भारत सरकार-रेल मंत्रालय अनुसंधान अभिकल्प और मानक संगठन

# MODIFICATION SHEET NO. RDSO/2018/EL/MS/0470, Dated 18.06.2018

Provision of LED type light for exchanging signals with train passing staff.

Figure 1: Location of LED lamps

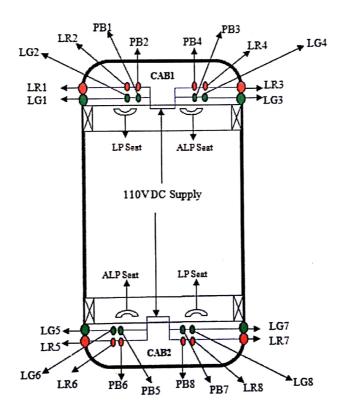
To avoid the frequent opening of windows of air conditioned cab for exchanging the signals, a LED based signal exchange lamp is required to be provided outside the cabs with control push button at the ALP/LP desk for exchange of signals. If cab doors/windows are opened frequently, this activity reduces the effectiveness of Cab AC. Therefore, provision of exchanging of signals is considered through LED light. These lamps shall be operated by push buttons as shown in Figure 1. The lamps with push button shall be connected in series with a feedback light as repeater for ensuring the glowing of respective lamp when ever push button is pressed.

- 4.1 The Green & Red LED lamps along with Push Buttons shall be provided as per Figure 1.
- 4.2 The 110 V supply taken for the purpose shall be through suitable rating of fuse to avoid failure of control circuit of loco in case of fault in LED based signaling circuit. The 110 V supply for LED type signaling circuit shall be taken from wire No. 003(+ve) & B-in conventional electric locos and from wire No. 2068(+ve) & 2050(-ve) in 3-phase electric locos.

4.3 Indication lamp outside the loco shall be LED type similar to Marker Light as per specification no. ELRS/SPEC/PR/0022 (latest).

- 4.4 All push buttons shall be similar to Push button for Fast BP charging i.e. BPSW with single N/O contact as per specification No. CLW/ES/S-8 (latest).
- 4.5 All repeater lamps shall be similar to indication lamp provided in signaling lamp box of locomotives on driver's desk as per specification No. CLW/ES/L-24(latest).
